**CALIFORNIA COASTAL COMMISSION**

REVISED STAFF REPORT: REGULAR CALENDAR

APPLICATION NO.: **1-03-028**

PROJECT DESCRIPTION: Merge two parcels resulting in one parcel of approximately 34,400 square feet and relocate the existing residence approximately 85 feet to the east.

Figure 7. Desired Rohner building area. This building area is nine (9) feet landward of the minimum setback line determined using the methodology discussed in the text.

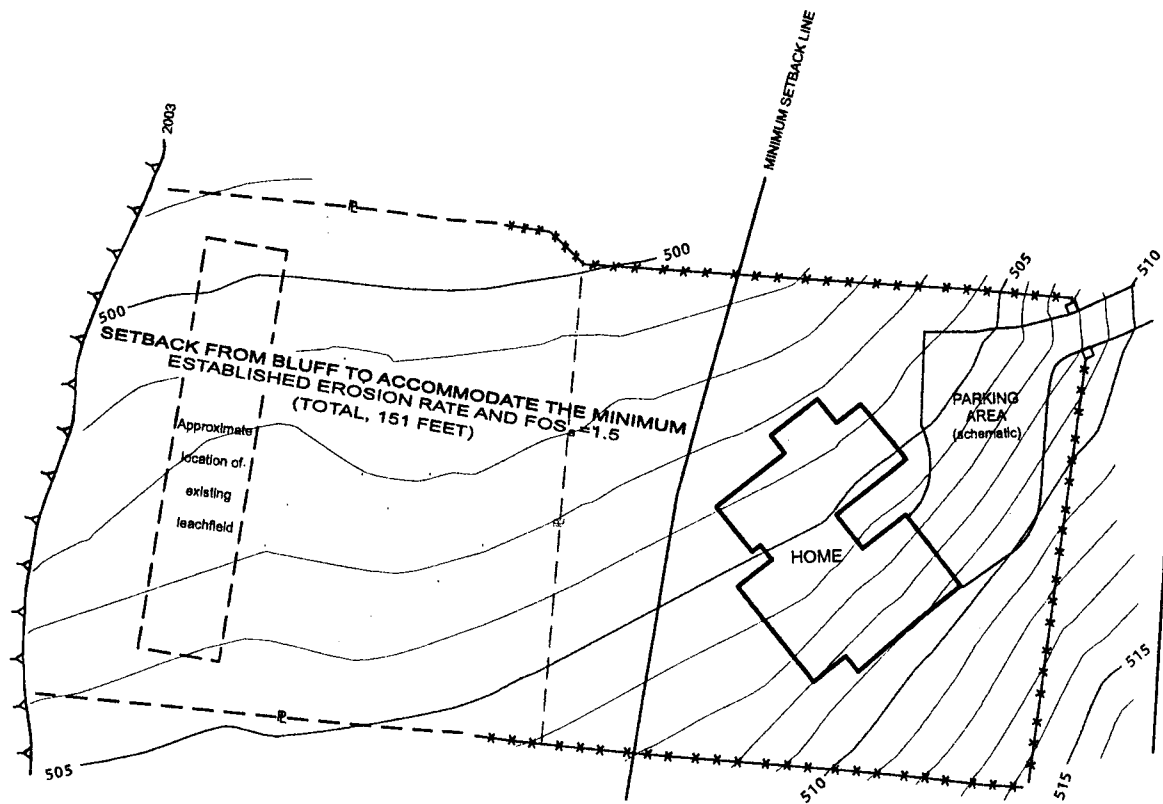
Based on the results of the analysis of long term bluff retreat and slope stability, BUSCH recommends a minimum setback line from the present bluff edge of 160 feet to protect the relocated house over its assumed 75-year lifespan. This setback consists of the 76-foot slope stability setback plus 75 additional feet to account for the 1-foot per year bluff retreat rate, and 9 additional feet to provide an "extra measure of prudence." BUSCH also recommends that the relocated home use a home foundation that would facilitate moving the house in the future.

Based upon the geologic report prepared by the applicants geologist and the evaluation of the project by the Commission's staff geologist, the Commission finds that the risks of geologic hazard are minimized if the residence is set back approximately 160 feet or more from the bluff edge as proposed. However, given that the risk cannot be eliminated and the geologic report cannot assure that shoreline protection will never be needed to protect the residence, the Commission finds that the proposed development is consistent with the Coastal Act only if it is conditioned to provide that shoreline protection will not be constructed. Thus, the Commission further finds that due to the inherently hazardous nature of this lot, the fact that no geology report can conclude with any degree of certainty that a geologic hazard does not exist, the fact that the approved development and its maintenance may cause future problems that were not anticipated, and because new development shall not engender the need for shoreline protective devices, it is necessary to attach Special Condition No. 5 prohibiting the construction of seawalls and Special Condition No. 6 requiring the waiver of liability.

Figure 7. Desired Rohner building area. This building area is nine (9) feet landward of the minimum setback line determined using the methodology discussed in the text.

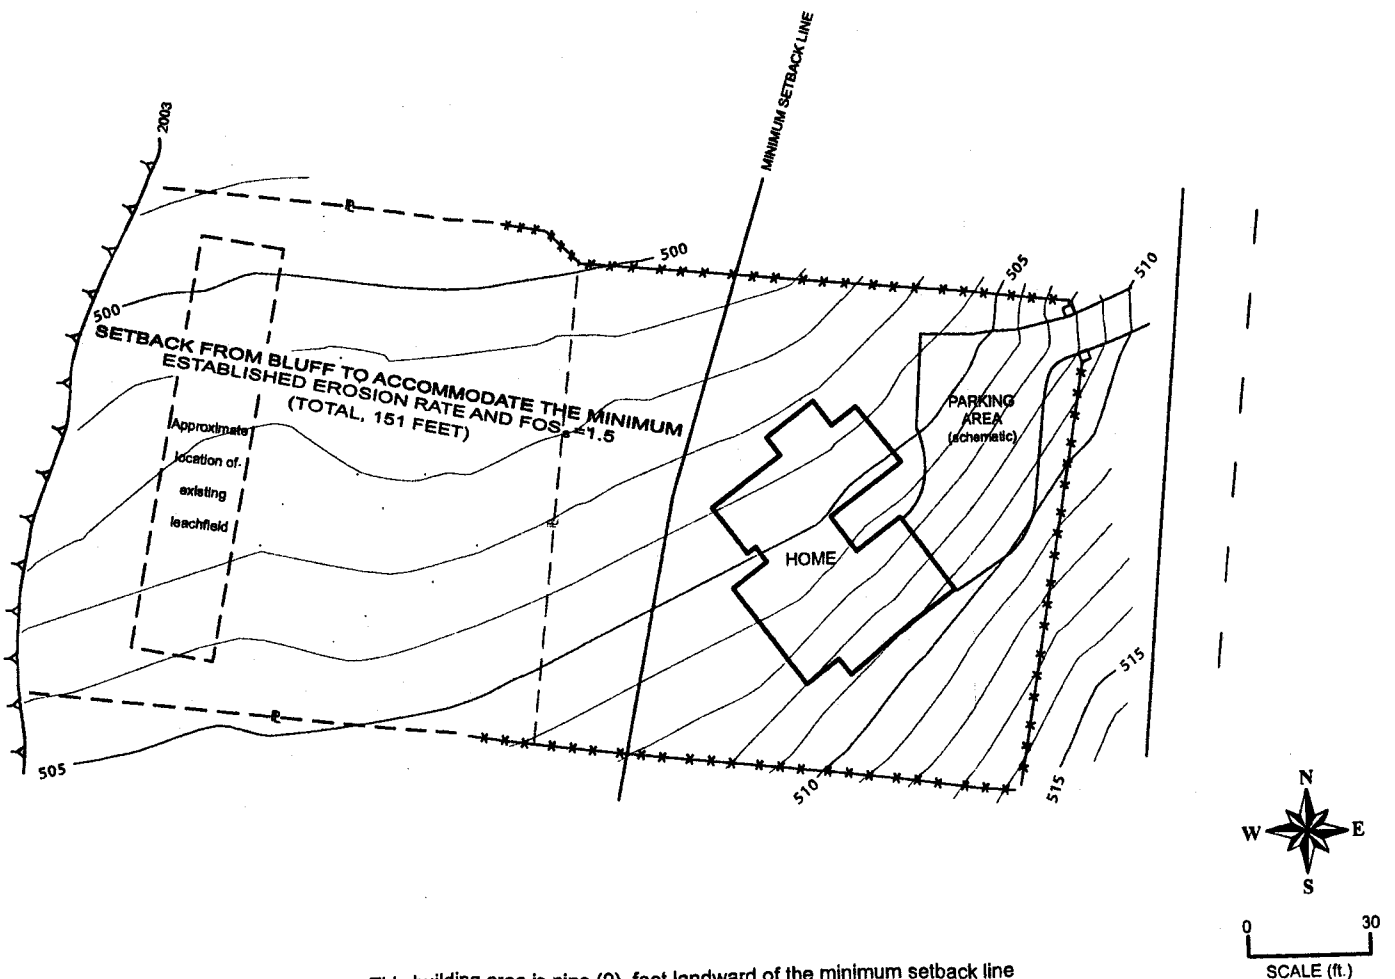
results in a 75-100 year bluff-erosion setback. In order to assure that at the end of this time the development still has an adequate factor of safety against landsliding, the 76 foot slope stability setback must be added. Thus, the minimal setback to assure stability for 100 years would be 176 feet, or 151 feet for 75 years. See Johnsson (in press) for a discussion of other assumptions that go into this analysis.

Reference (4), in contrast, recommends a setback of 160 feet. This is based on an assumed economic life of 75 years with an added "extra measure of prudence" of 9 feet. It is my opinion that this setback assures geologic stability for approximately the next 84 years.
